**HIGH COURT OF MADHYA PRADESH: JABALPUR**

**// CLARIFICATION //**

No. Reg(IT)(SA)/2019/1026

**Subject:-** The matter regarding to publish the clarification / reply of Pre-Bid meeting dated: 01<sup>st</sup> July, 2019 regarding the tender for the supply, installation, commissioning and maintenance of Display Panels, thin client monitors with VGA splitters and other accessories for the Subordinate Courts in the State of Madhya Pradesh with reference to the tender no. Reg(IT)(SA)/2019/893, Dated:21.06.2019.

**Proposed Drawing**

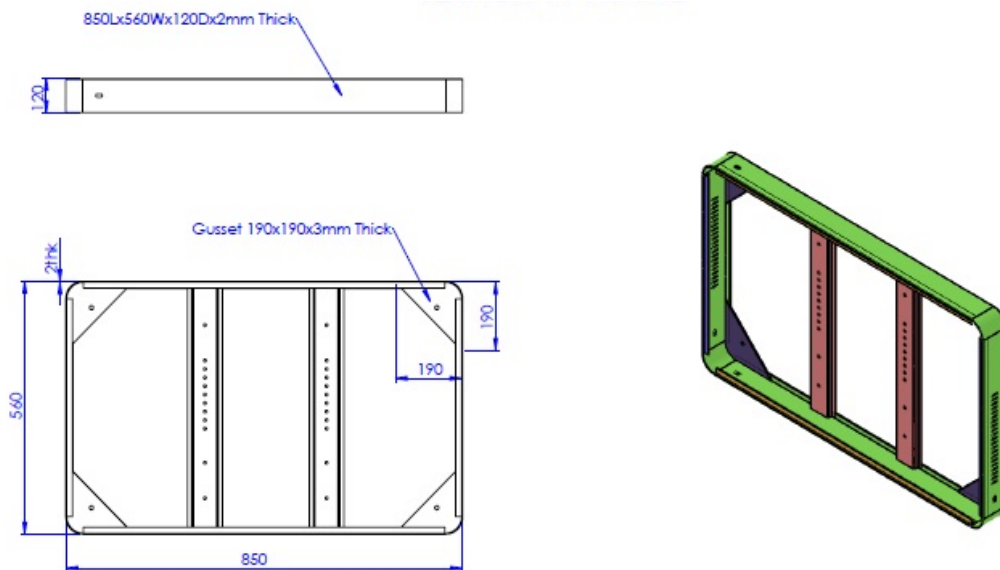
<p>Energy certifications as such certifications are not mandatory for Institutional requirement. Instead we would like to state that our typical power consumption is among the lowest in the 32 inch category i.e. 50W for Rated power consumption and less than 0.5 W for standby conditions.</p> <p>Also, we would request the concern authority to consider HD (1366 x 768) as a resolution option.</p> <p>As the screen size is 32 inch, the pixel are tightly placed to give similar clarity with HD compared to Full HD.</p>	
9	Section VII/ Page No. 42 <b>(M/s Veltronics India Pvt. Ltd.)</b>	MS-STEEL security frames for ITEM <b>Serial no. 01</b> along with screen having aesthetic looks and excellent quality	Quality of 32" Display Enclosure should be define, please find enclosed Sample Picture of Enclosures and its drawing.	Yes the drawings are included in the reply of pre-bid meeting as per details given below.
